Groundwater Application Review Summary Form

Application # G- 19468 re-review

GW Reviewer Travis Brown Date Review Completed: 8/13/2025

TO: Water Rights Section Date 8/13/2025
 FROM: Groundwater Section Travis Brown
 Reviewer's Name
 SUBJECT: Application G- 19468 re-review Supersedes review of 5/9/2025
 Date of Review(s)

Hydrographs

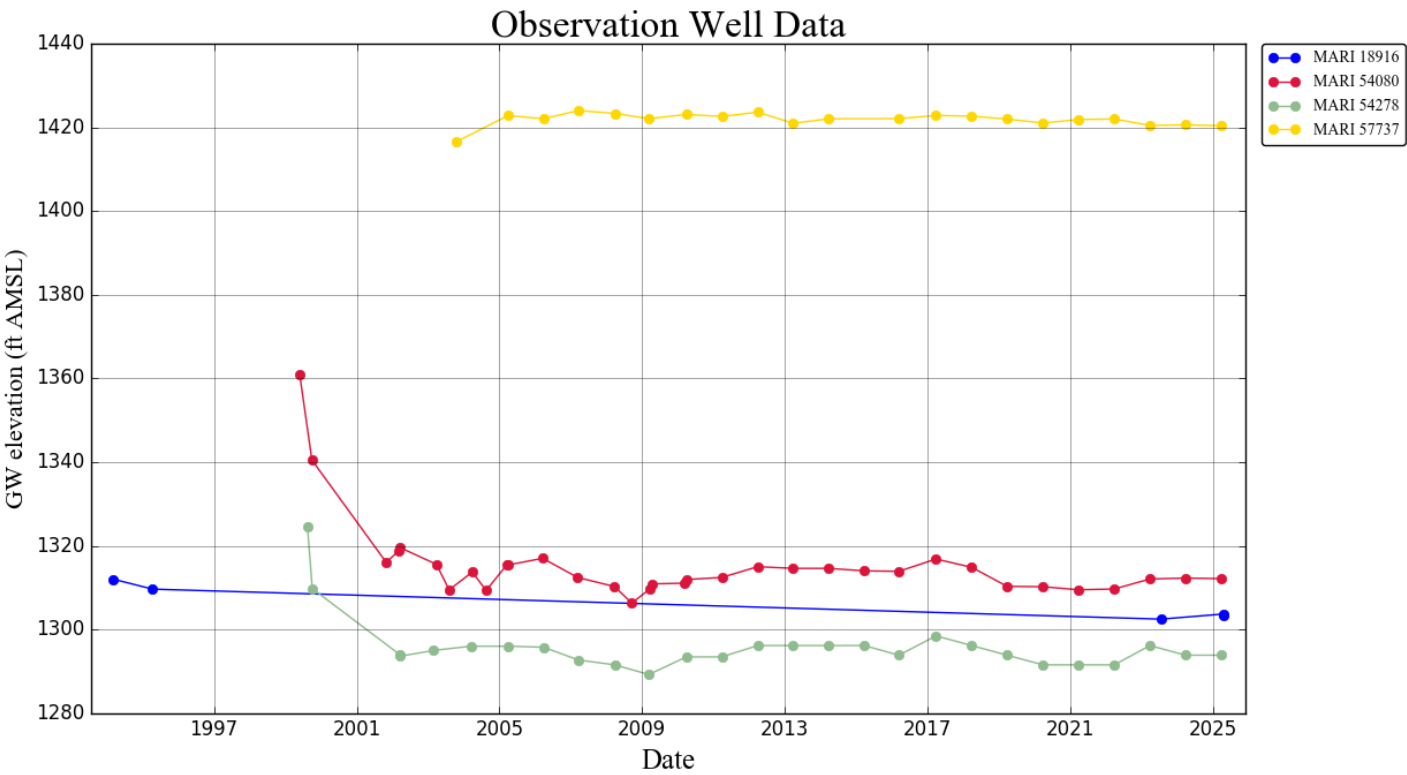
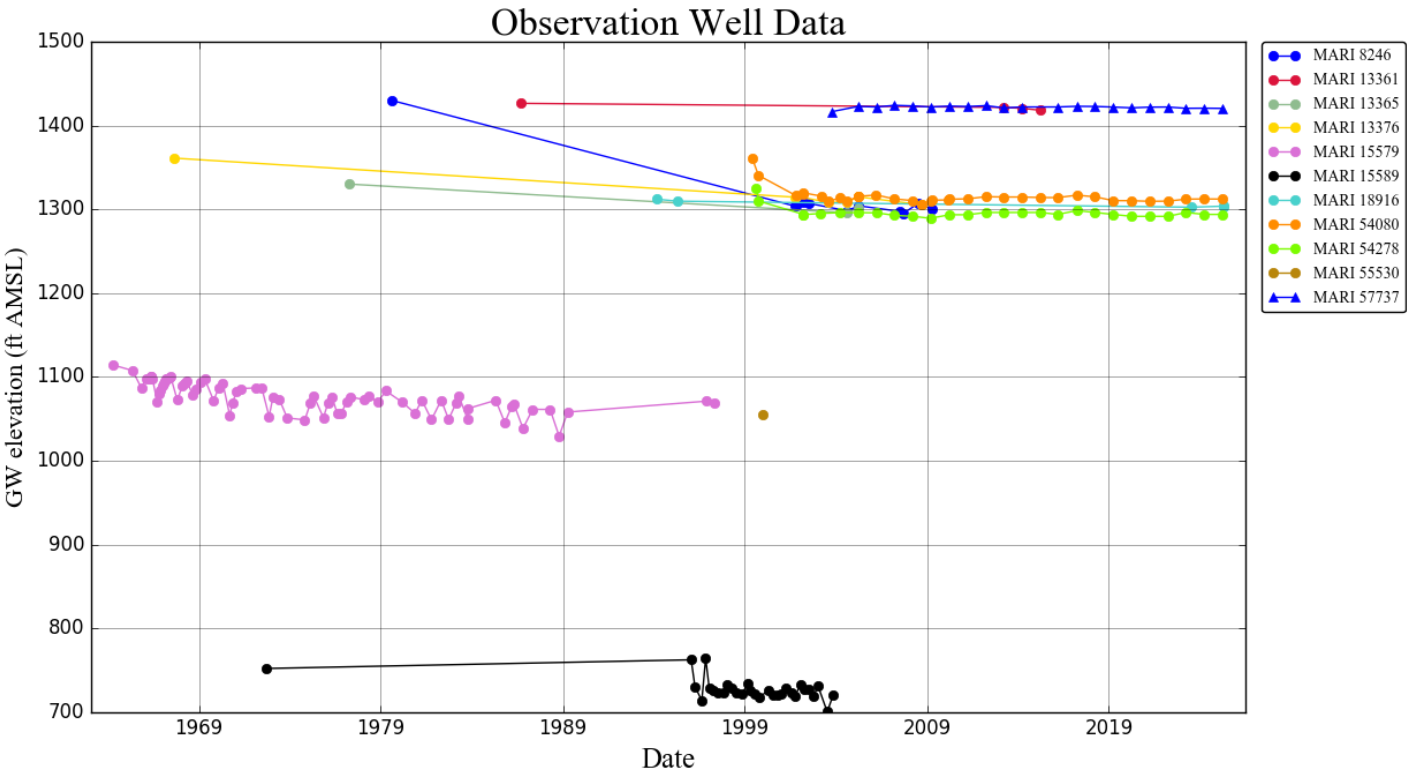
The closest well with any time series water level data is MARI 15579, ~2.5 miles to the southwest of the proposed POA. MARI 15579 exhibited an overall decline in water level of ~56 ft between 1965 and 1989 but showed ~11 ft of recovery between 1989 and 1997, although it was still down ~45 ft from its highest value in 1965; more recent data was not available. The nearest well with recent water level data is MARI 18916, ~2.9 miles northeast of the proposed POA, which has shown an overall decrease in water level of ~8.5 ft since it was drilled in 1994 (see attached Hydrographs). Wells further to the north with current data show relative stability from the early 2000s through 2025 (see attached Hydrographs). However, between 1999 and 2002, MARI 54080 showed an overall decline of ~42.3 ft from the water level reported on its well completion report in 1999. Similarly, between 1999 and 2002, MARI 54278 showed an overall decline of ~31.0 ft from the water level reported on its well completion report in 1999. This pattern of steep initial decline followed by subsequent stabilization may indicate these wells (MARI 54080 and MARI 54278) commingle multiple aquifers. The preponderance of the current water level data indicates the proposed aquifer is not over appropriated.
